Application for DCO by FOSSE GREEN
Representation by Interested Party reference [REDACTED]
Deadline 5

Summary of Submissions

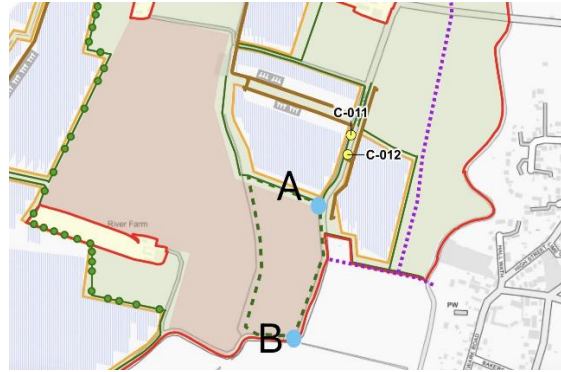
11.0 The Framework Landscape and Ecological Management Plan (REP3-028) contains drafting errors. Paragraphs 5.3.57 and 5.3.58 as drafted do not make any sense:-

“5.3.57 Measures for modified grassland (moderate condition) will focus on a regime of:

5.3.58 Sheep grazing (if undertaken) at a stocking density and time periods which favour sward diversity within the modified grassland (moderate condition).

- a. Visual inspections during the growing season.
- b. Control of undesirable species (e.g. arable weeds) and injurious weeds to prevent colonisation and domination of the grassland using spot treatment of herbicide.
- c. The results of annual monitoring surveys will be used to adjust the management regime to maximise biodiversity.”
